Rezoning Transportation Analysis

Petition Number: Insert Zoning Petition #2022-006

Date	Description
06-23-22	First Review (PDM)
07-20-22	Second Review (PDM)

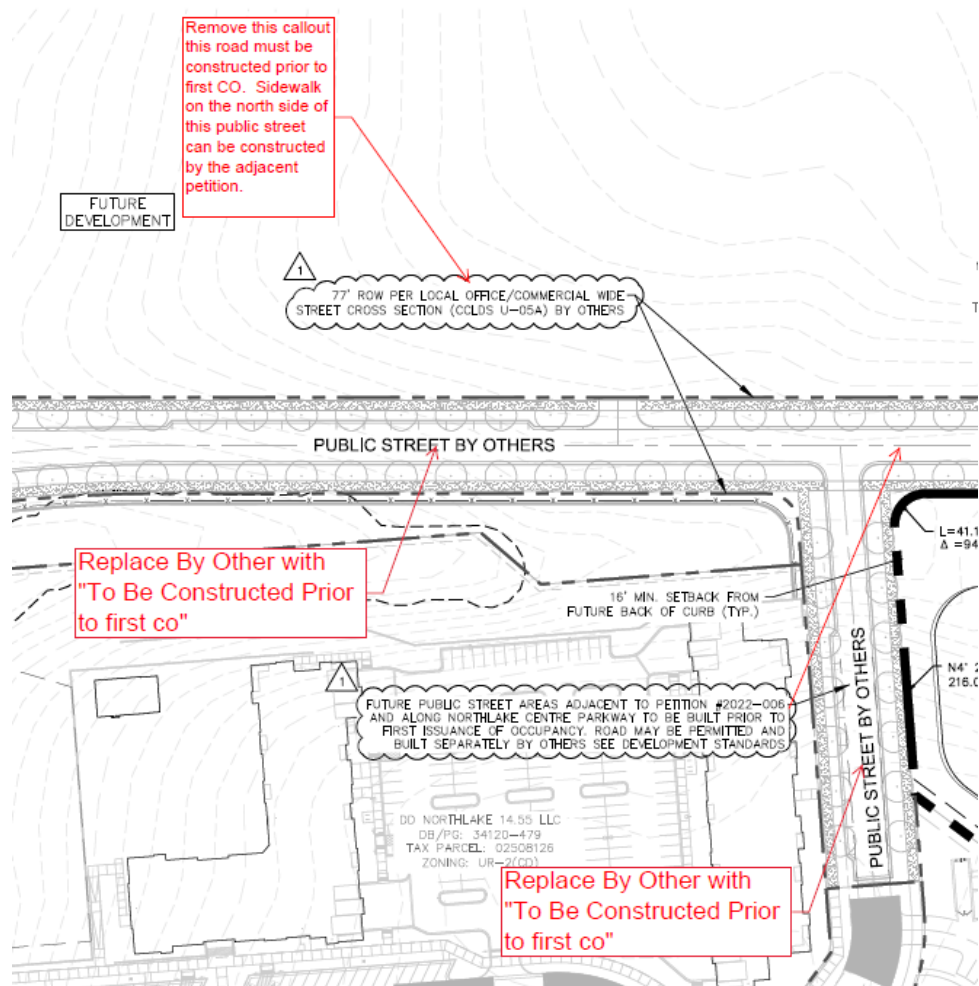
- Outstanding Comment from 06-23-22:** Revise site plan and conditional note(s) to commit to installing both public streets that are identified as "public street by others" on the site plan. A new access location on Northlake Centre Parkway will be required by CDOT for this petition. Coordinate roadway responsibilities with RZP 2022-010 as necessary.

Clarifying Comment (07-20-22): Remove "By Others" from the proposed public roadways and adjust callout for street installation commitments to include both public roads.

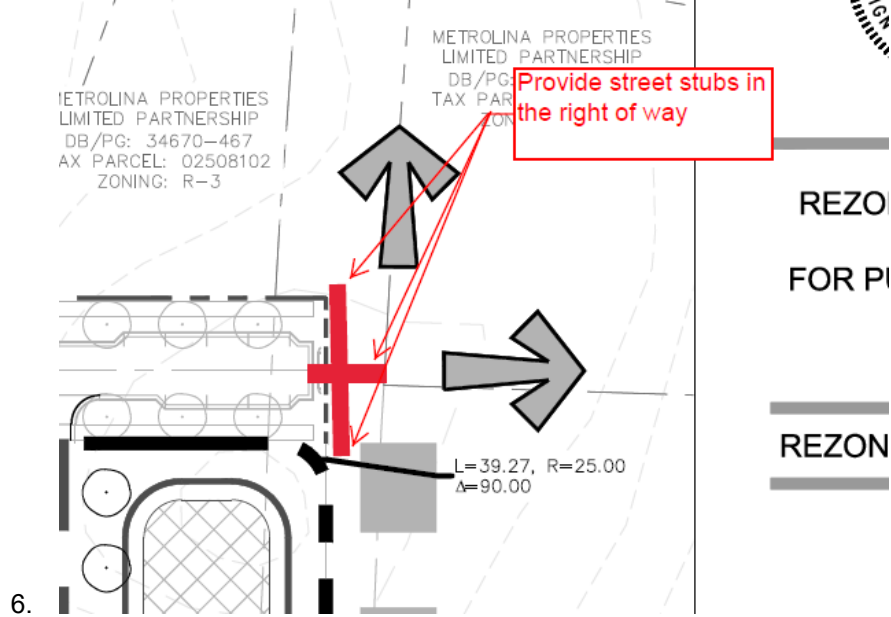
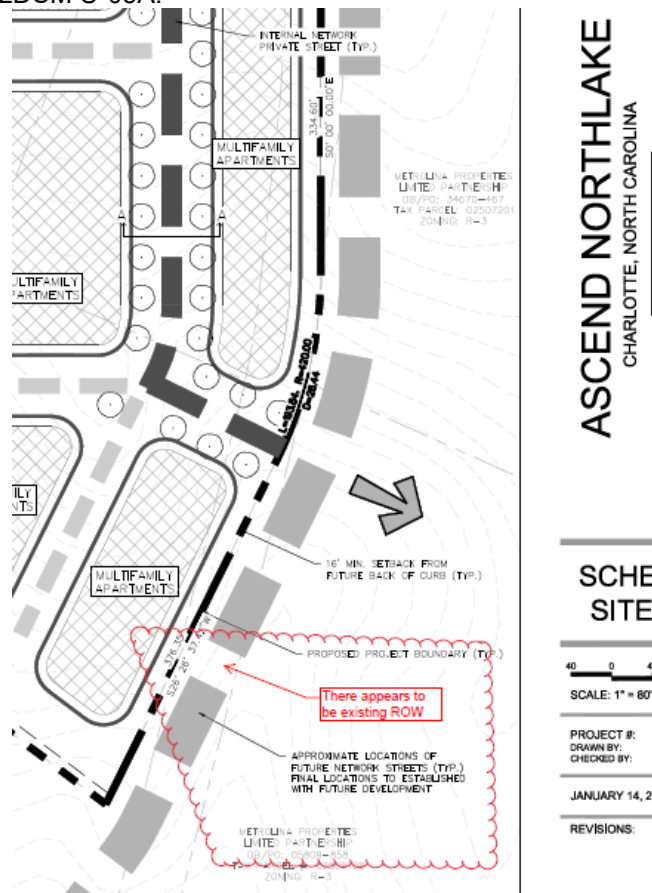
- Outstanding Comment from 06-23-22:** Revise site plan and conditional notes to reconcile the existing versus proposed ROW along the east side of the property. The future street alignment should fall within existing ROW. Verify ROW width and provide any additional ROW required for a commercial wide roadway section per CLDSM U-05A.
